REPUBLIC AVIATION CORPORATION
FARMINGDALE, LONG ISLAND, NEW YORK
• • • SERVICE DEPARTMENT • • •

No. 58

LANDING GEAR TORQUE TUBE ASSEMBLY

**FITTING THAT FAILS.
HYD. ACTUATING CYLINDER
ATTACHES TO THIS FITTING.**

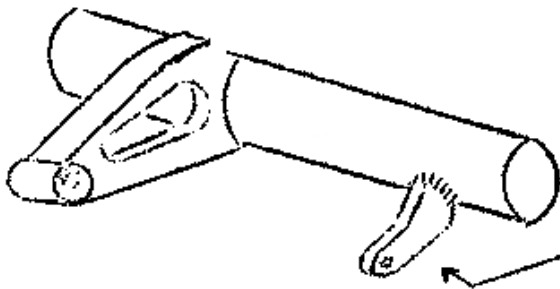
There have been a number of failures of the Landing Gear Actuating fittings. An examination with a 20X magnifying glass will determine if cracks at the base or in the weld are present. The item number is 1110 for the Torque Tube and Actuator Assembly. (Electrol, Inc, Drawing Number A5110).

A recommended repair is to grind off all existing weld down to parent metal and arc weld with nickel steel rod, building up the bead around the fitting.

The above inspection is to be complied with immediately.
